Subject: KNOCKING / SQUEAKING NOISE FROM FRONT SHOCK ABSORBER, CREAKING NOISE FROM FRONT LOWER ARM BUSHING	Bulletin No: 02-003/17
	Last Issued: 01/13/2017

This bulletin supersedes the previously issued bulletin(s) listed below: The changes are noted in Red beside the change bars.

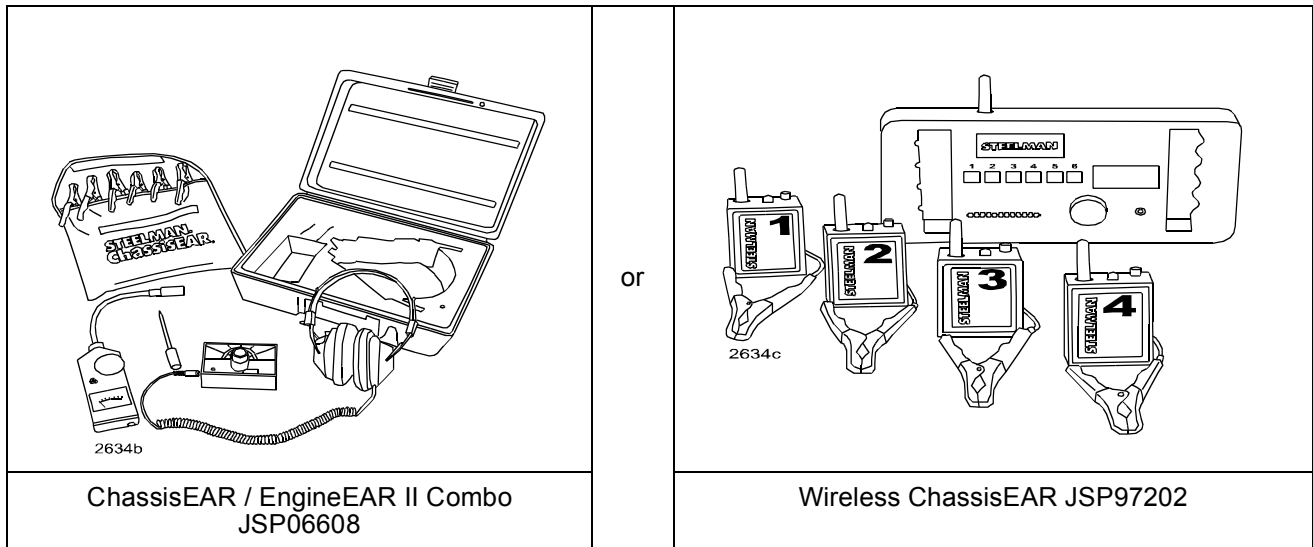
- upper front strut bearing (A) damage. (CX-5 and Mazda6)
- stick/slip between the front strut bearing and coil spring. (CX-3, CX-5 and Mazda6)
- the bump stopper (C) may be contacting the strut bearing when the front shock absorber is compressed, causing a popping noise. (Mazda6 only)
- The front lower arm bushing (D) is making a stick-slip noise in wet road conditions. (CX-5, Mazda6 and CX-9).

1. The material and production method of the front strut bearing (A) has been changed. (CX-5 and Mazda6)
2. A protector has been installed onto the coil spring. (CX-5 and Mazda6)
3. The shape of the bump stopper (C) will be modified in the future. (Mazda6 only)
4. The shape of the coil spring has been changed. (CX-3 only)
5. Friction of the lower arm bushing has been reduced by adding a dry coating. (CX-5, Mazda6 and CX-9).
